Product Change Notice (PCN)

Subject: Site addition of Final Test, Visual-Inspection and Packing Process for the RH850/F1L series.

PCN# : [AMBD-2022-0647]

Label example: R7F7010063AFD-C#BA4 (F1L-2M,144pin, Cu-wire)

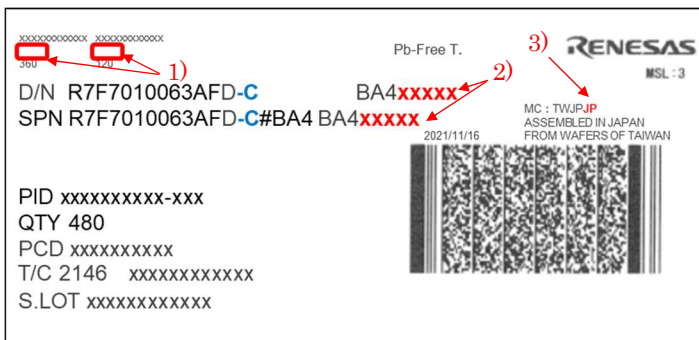
The parts of the red characters and the red squares are different for Nishiki products.

- 1) There are no descriptions about T/C Code for combination LOTs.
- 2) The number of digits for Internal Code is different.
- 3) MC Code is different from TeraPower products (The same as Tera Probe products).

In addition, there is not the description of "-C"(Blue) in Part Number for Au-wire products.
